NuMI Extraction Lambertson Configuration at MI60

David Johnson

April 19, 2002

Numerous improvements to the NuMI primary beamline have been proposed due to the change from slow spill, concern for ground water activation, sensitivity to errors, the reduction of the carrier pipe length, and tuneability. The improvements have led to a re-design of the transport section of the primary beamline to keep the lattice functions (beta and dispersion) smaller. The most notable changes have been to carry the FODO lattice of the MI through the line breaking up the long bend strings.. Since the carrier pipe distance was cut by a factor of two to about 50 m, the more practical approach of creating a straight section, similar to the Tevatron was possible. Additional effort has gone into optimizing the extraction section by investigating the closed orbit, kicker strengths, and Lambertson configurations to improve aperture and reduce extraction losses. This note examines the current Lambertson configuration proposed at the last review.

Figure 2. Cross section of MI c-magnet with the MI beam pipe. Centerline of c-magnet to MI is 4.6 inches. The horizontal offset for the NuMI is approximately .72 inches from MI centerline (offset as shown is greater). The inside aperture of the c-magnet beam pipe (.060) is 1.48"H x 3.88" H.

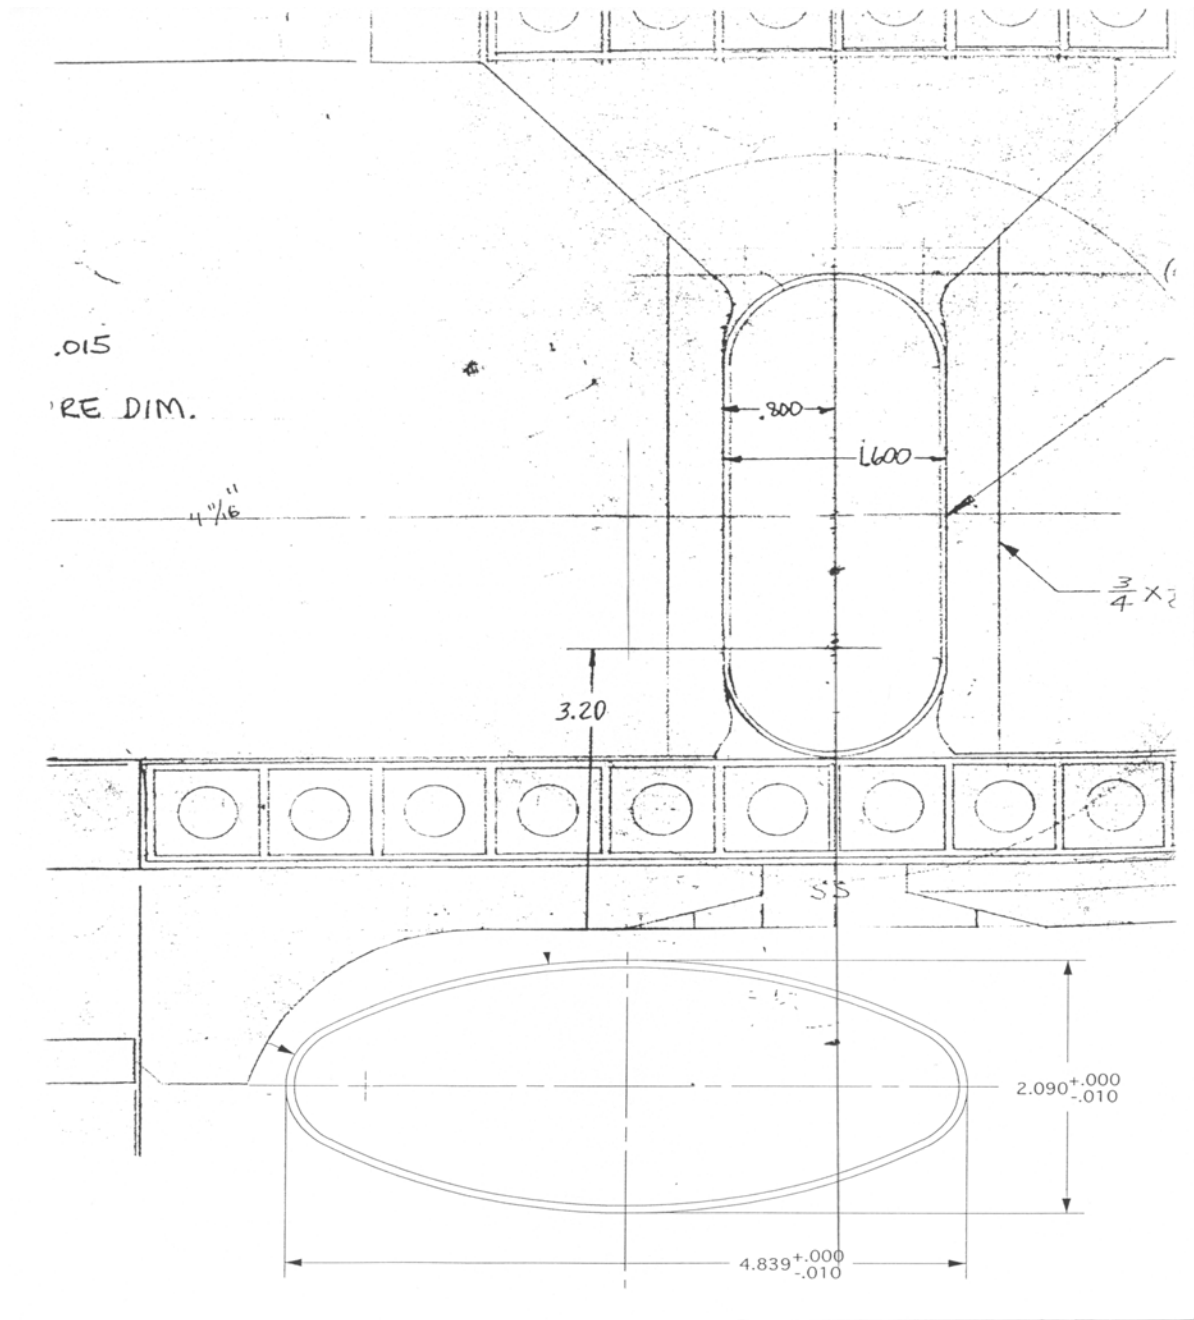
Figure 2 shows a cross section of the MI c-magnet steel in relationship to the MI beampipe. From the steel septa to the flange centerline is 87 mm. Note that the MI beampipe is shown 1/4" below the steel of the c-magnet. This is the minimum elevation of the steel due to the interference of potted coil pack, which extends about 8" beyond the steel. Installing the c-magnet at a pitch of approximately 24 mr [i.e. $(\theta_{out} - \theta_{in})/2$], the difference in elevation of the flange is approximately 0.192". From this cross section, the MI to c-magnet flange centerline is approximately 4.6" (117 mm). This defines the minimum geometrical vertical placement of the c-magnet. The magnet is shown horizontally offset by ~1.5". This represents the maximum horizontal offset. The expected offset in the NuMI case is more like 0.72".

The magnet has approximately 3.2 mm sagatti calculated from $\{\delta = (L/\theta) (1-\cos \theta/2)\}$. To maximize the vertical aperture through the c-magnet, the beam should enter and exit the magnet approximately $\delta/2$ (1.6 mm) above the magnet centerline. This implies that the optimum elevation of the beam trajectory at the entrance to the c-magnet should be approximately 119 mm above the MI centerline.

Careful inspection of the second calculation and the c-magnet geometry, it is conceivable that the c-magnet can be installed at the less than the 4.6" from MI centerline with steel touching (< 100mils) the MI beampipe. The beam could enter the magnet roughly 1"

below the flange centerline and potentially still in the good field region (fig.3). It would exit slightly above the centerline. The pitch of the magnet would be adjusted to less than the previously calculated sagitta.

Figure 3. Field uniformity of ICA001 at 2800 A (nominal operating current at 120 GeV/c)

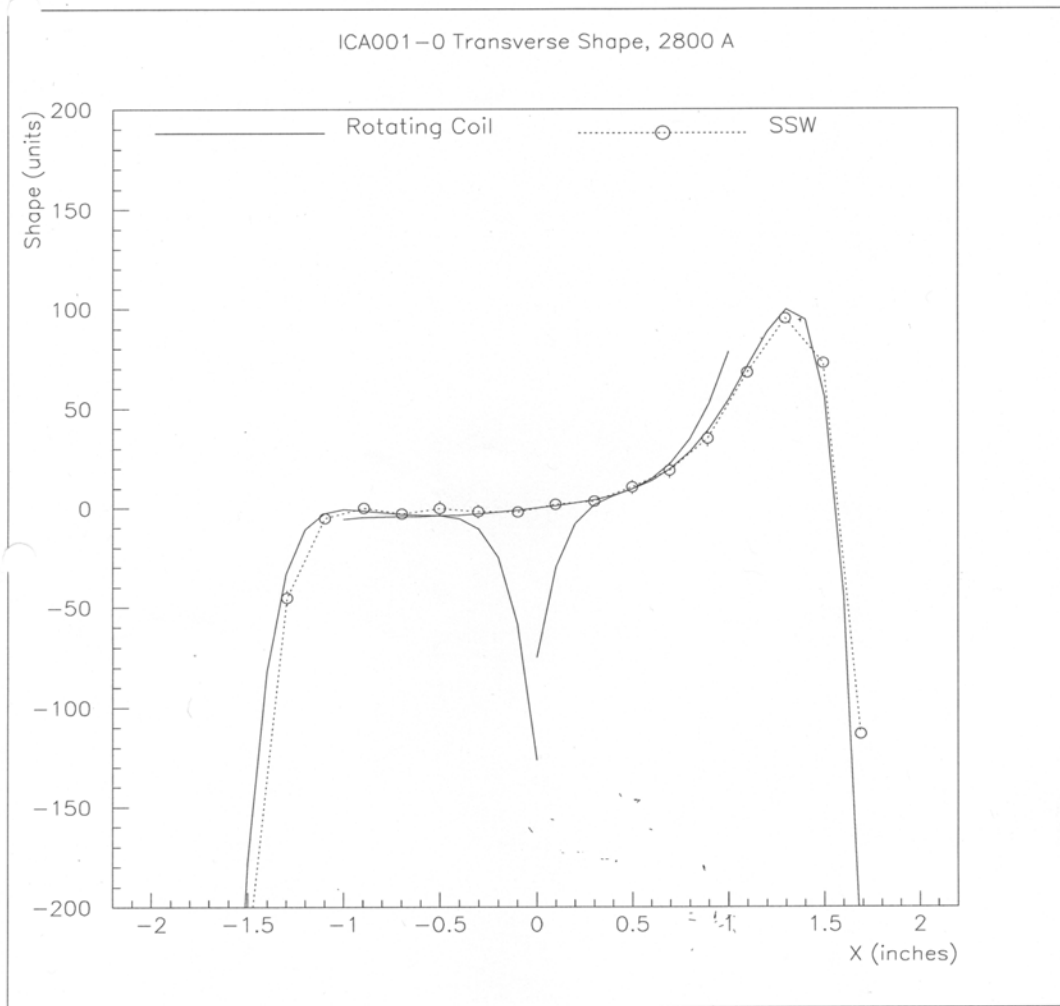
Figure 3 shows the field uniformity of one of the new MI c-magnets, ICA001, across the 4-inch aperture on axis. The magnet was rotated 90 degrees such that the 4" aperture was horizontal. The "c" of the c-magnet is toward negative x (i.e. figure 2 rotated clockwise). The data was for an excitation of 2800 A for an integrated strength of about 3.5 T-m or about 10 kG. This is close to the excitation required by NuMI. Data are plotted for three positions of a rotating coil and are compared to the measurements by a stretched wire system. The y-axis is $\Delta B/B$ in units of 10^{-4} . The field is clearly uniform between $-1''$ and $+0.5''$. The gradient between $+0.5$ and $+1.2''$ is on the order of 5-6 kG/m and falls off rapidly beyond $1.2''$. The main concern is the rapid fall off of the field beyond $-1.2''$. The dB/dx of $10\text{kG} \cdot 200 \cdot 10^{-4} / 0.2$ inches gives a gradient of about 40 kG/m. The field shape is fairly independent of excitation until saturation becomes dominate at about 3500 A when the field starts falling off closer to the center of the aperture.

Figure 4: Comparison of closed orbit at 120 Gev for that a) quad displacements defined in the current design (A. Drozhdin) - solid line and b) utilizing corrector/quad displacement from the design described in MI note 0258 – dashed line. Beam envelope shown is 4σ of a $40 \pi\text{-mm-mr}$ beam.

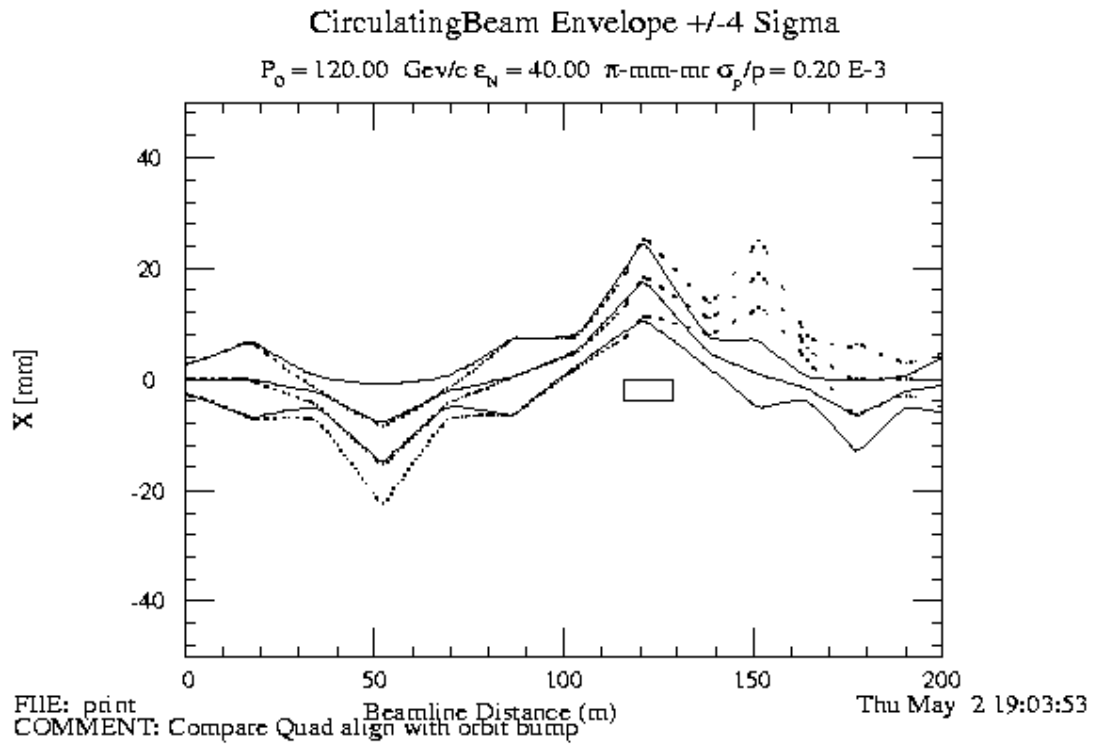
Inspection of the proposed circulating orbit raises some questions. The 120 GeV orbit is defined by quad displacements such that no correctors are needed at flattop. The correctors are then used at 8 GeV and up the ramp. With this philosophy, the correctors have plenty of strength for any orbit manipulation. The quad displacements taken from the design note are: Q602 = 1.582 mm, Q606 = -1.9642 mm, Q610 = -1.708 mm, Q612 = 0.0588 mm, and Q614 = 1.54 mm. These are used to create a counterwave bump centered on 604 for the kicker at 602 and control the circulating beam orbit through the Lambertsons. Whether quad displacements or correctors are used these two functions should be separated (i.e. the use of 602, 604, and 606 for the counterwave bump and 606, 608, 610, and potentially 612 for the Lambertson bump). Figure 4 shows the beam envelope for the orbit due to quad displacements, *solid line*, and the Lambertson septa (for all three lambertsons) as a box centered about -2 mm to the outside of the ring. Also

shown is the approximate closed orbit utilized in MI note 0258 shown as a *dashed line*. Here, the position at both Q608 and Q610 are kept to the inside, effectively keeping the beam farther to the inside through all the Lambertsons. As a side benefit this can be used to reduce the horizontal extraction angle out of the c-magnet. The counterwave bump at Q604 is about twice that is the current proposal, which will reduce the amplitude of the excursion due to the kicker. This was some with the superposition of a three bump (H602,H604,H606) and a four bump (H606, H608, H610, and H612). The exercise left to do is to optimize these orbit at all energies.

Figure 5: Circulating and extracted beam 4σ envelope at the face of LAM60A for the reduced current in the first Lambertson. The placement of the Lambertson is from the current proposal

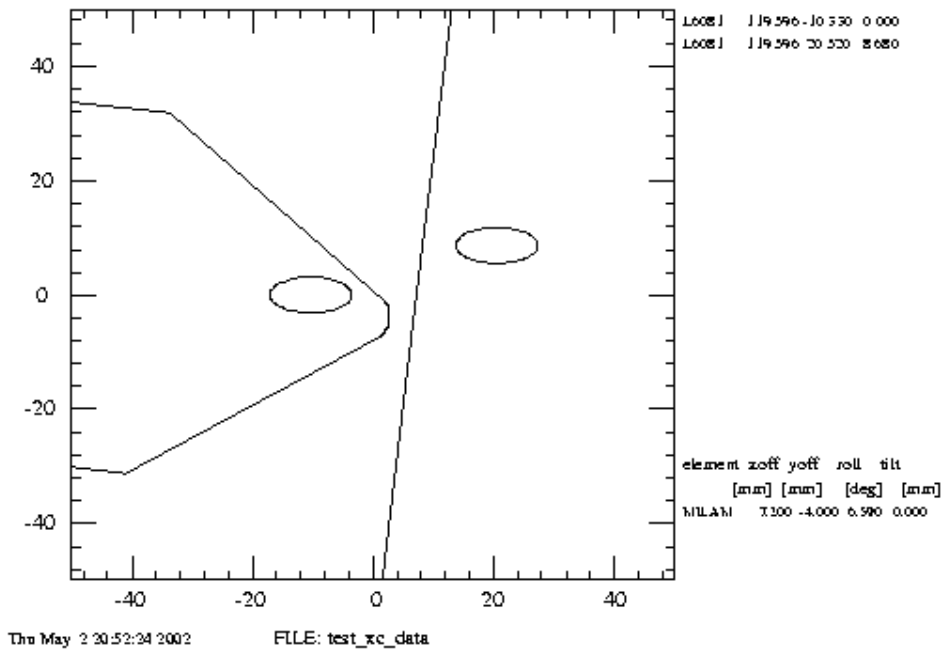
Since the orbit should be vertically flat, the vertical relative displacement of 6 mm effectively reduces the vertical aperture near the septa.

Figure 5 shows the Lambertson aperture shifted by the 3.2 mm (H) and -4 mm (V). The circulating and extraction beam ellipse represent the 4σ of a 40π beam at the downstream face of the first Lambertson. The circulating beam is shown at -12 mm and the extracted beam is shown at +20 mm and about +8 mm in the vertical. These positions are tunable and are used only as an example. One can see that shifting the septa down by 4 mm at this location is a bit too far.

Figure 6: Shows the effective septum thickness with respect to the MI centerline. The septa have been aligned according to the positions listed for the current proposal.

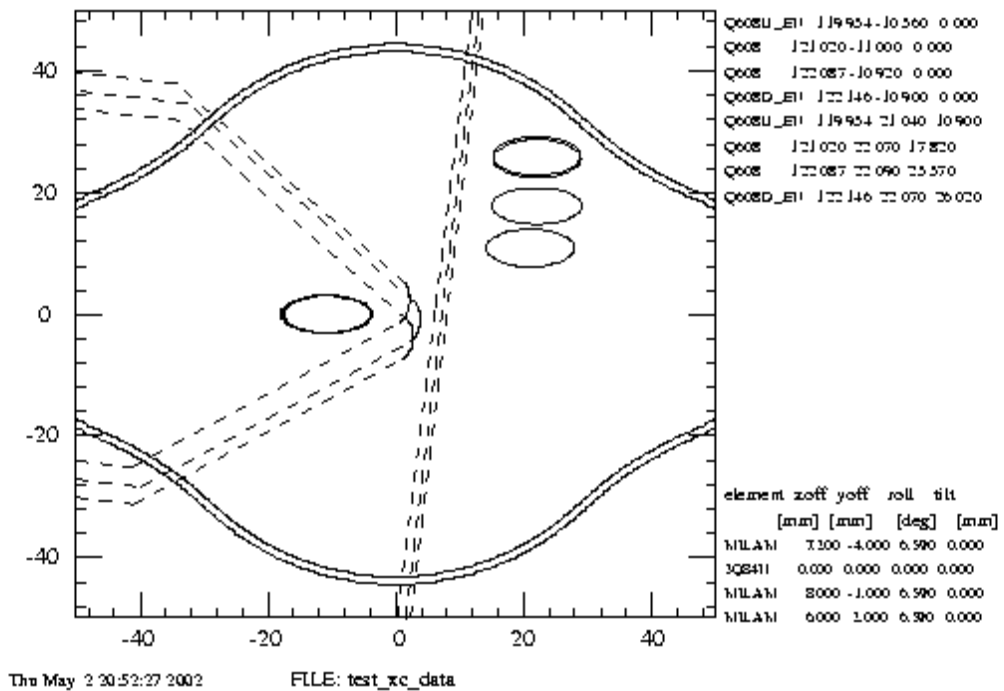
Figure 6 is used to illustrate the reduction of the effective vertical aperture due to the proposed vertical offsets, particularly when the beam comes closer to the septa. This would effectively reduce circulating aperture and produce a narrower beam loss free channel. The ellipses again represent the circulating beam (tunable) and the extracted beam at the end of the first Lambertson, at the entrance to the Q608, and at the exit of Q608 next to the BPM HP608.
